PORTLAND STATE UNIVERSITY

**Blumel Hall Remodel RFP for
General Contractor (GC) Services**

ADDENDUM #3

June 4, 2012

A5.3

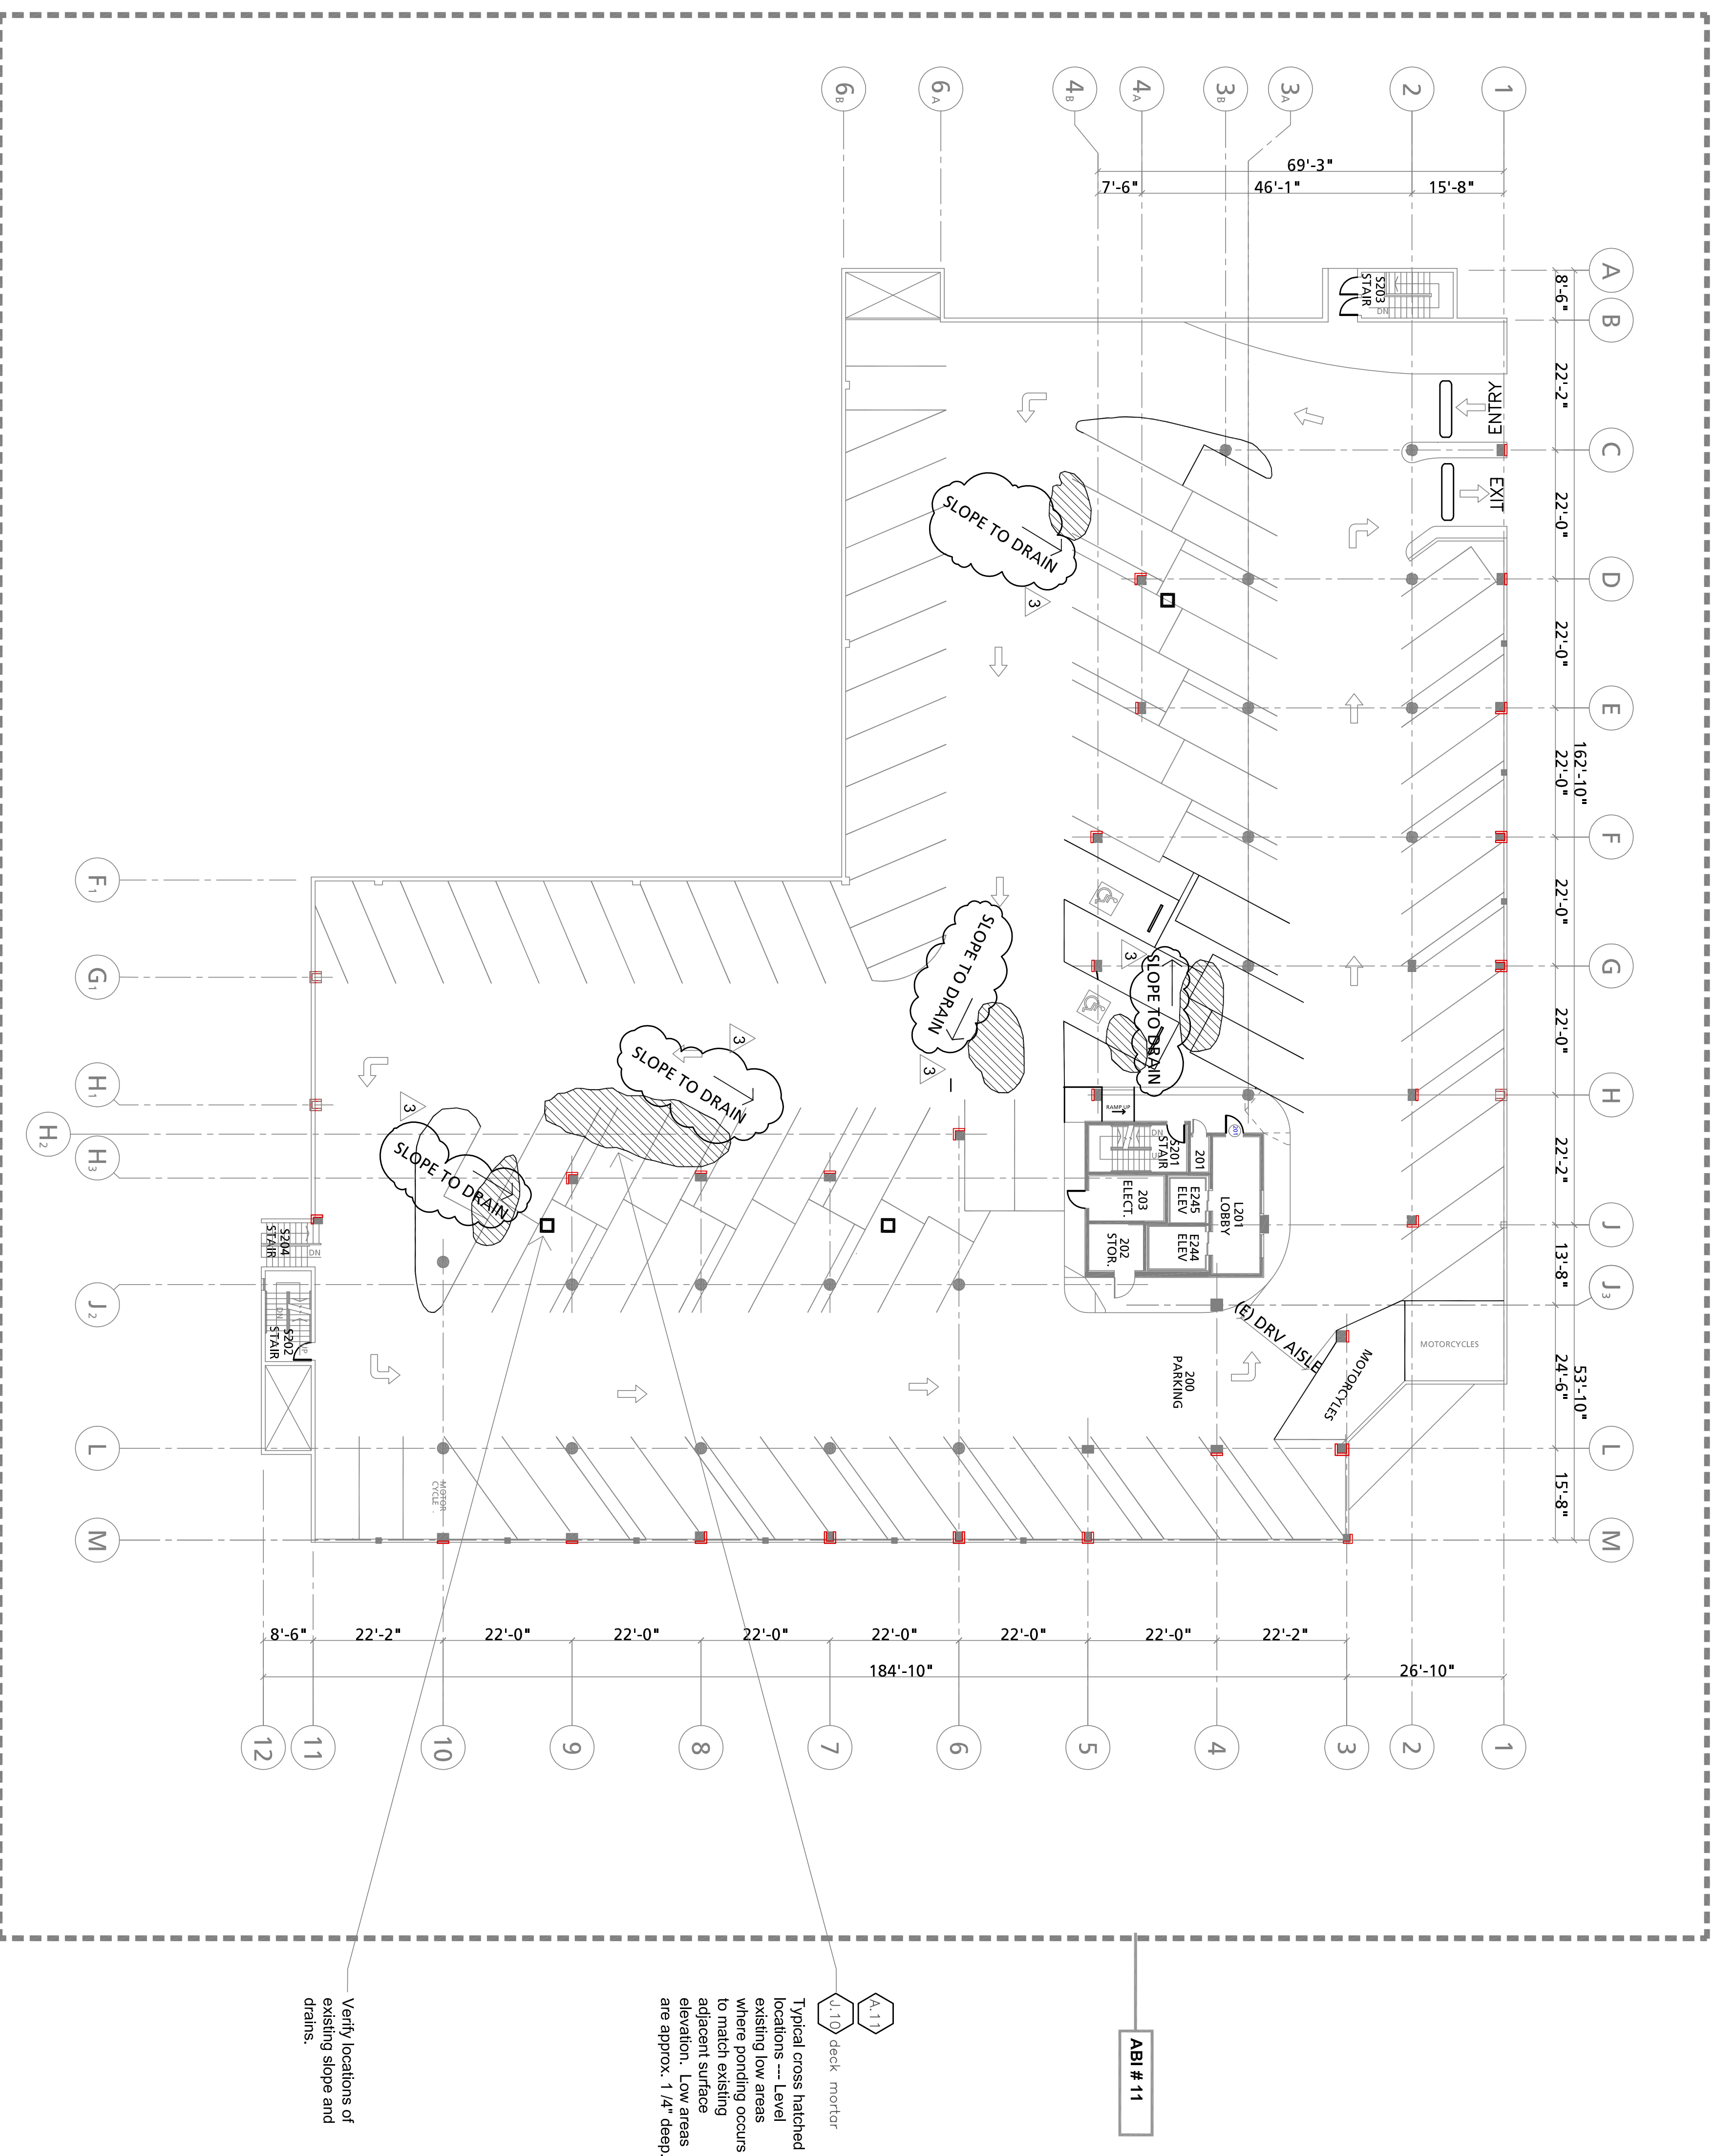
1. Delete Sheet A5.3 and replace with the attached revised sheet – Added “Slope to Drain” notes.
2. Delete Sheet MP7 and replace with the attached revised sheet – Added to note 1.8 in order to reference architectural sheets for specific patching requirements.
3. Delete Sheet MP12 and replace with the attached revised sheet – Added general note; Re-specified L-1, previous product had been discontinued.
4. Delete Sheet MP13 and replace with the attached revised sheet – Added general note.
5. Delete Sheet MP15 and replace with the attached revised sheet – Deleted the depiction of the concrete slab, it is inaccurate and the structural drawings should be referenced for accurate detail.
6. Delete Sheet MP16 and replace with the attached revised sheet – Changed plumbing fixture schedule to reflect new L-1.
